CHANGE ORDER

No.__2

| PROJECT: Lake Village Ph II-A Water Qualit | ty Improvement Proje | ct | |

LAKE VILLAGE PHASE II-A WATER QUALITY IMPROVEMENT PROJECT EIP PROJECT #679

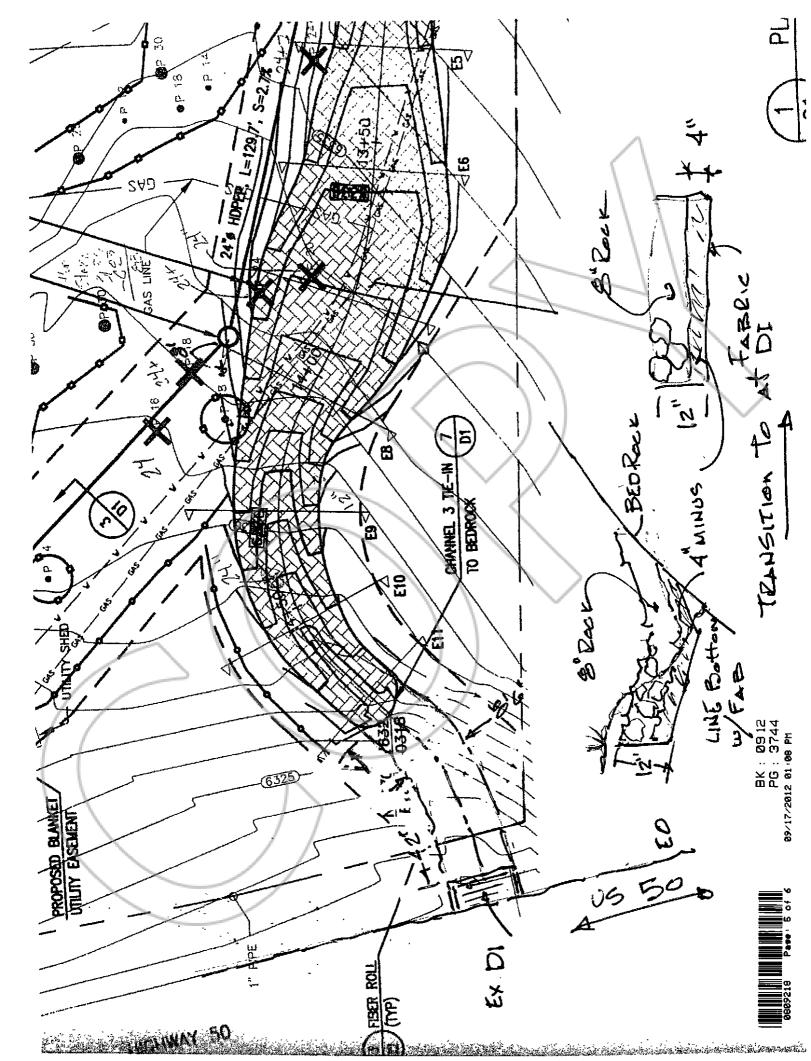
| PROJECT: Lake Village Ph II-A Water Qualit | ty Improvement Proje | ct | |
|--|------------------------|------------------|----------|
| Description: Add Rip-Rap ditch to lower end of Arr \$8,156.50. | mor-flex Channel per a | ttached drawing, | 55 |

Reason for Change Order: Neither the plans nor specifications address protecting the +/-32ft. from end of Armor-flex to the NDOT R/W; this portion of channel needs to be protected to provide a complete project.

Rip rap lower drainage area section from end of Amorflex block to NDOT right-of-way.

Proposed work includes;

Clear & grub / material removal Geo fabric installation 1½"-2" rip-rap rock

12" (approximately) rip-rap rock placement
